HIGHWAYS RESPONSE

Our Ref: 23/02094/FULMAJ

The Kennet Shopping Centre, Newbury

Full planning permission for the redevelopment of the Kennet Centre comprising the partial demolition of the existing building on site and the development of new residential dwellings (Use Class C3) and residents' ancillary facilities; commercial, business and service floorspace including office (Class E (a, b, c, d, e, f, and g)); access, parking, and cycle parking; landscaping and open space; sustainable energy installations; associated works, and alterations to the retained Vue Cinema and multi storey car park.

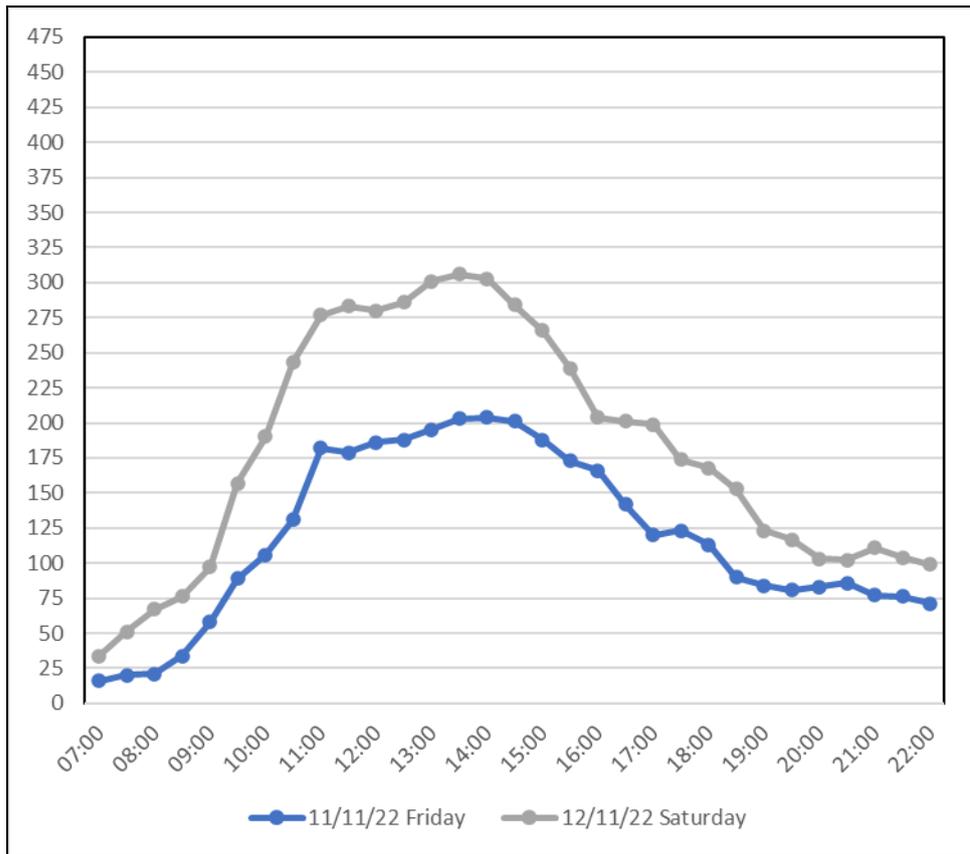
14. There is concern about service access and car park access being in the same place with service vehicles mixing with a car park. Service area should be kept separate from the car park movements. I am assuming that the proposed car park will be used by residents only.

15. There is concern over the routes cyclists will need to take to get to the cycle stores including through proposed car parks.

16. I am concerned however, that larger vehicles such as HGV's will be unable to use either of the new accesses. I consider this is an issue that should be addressed. Will HGVs be likely to visit the site?
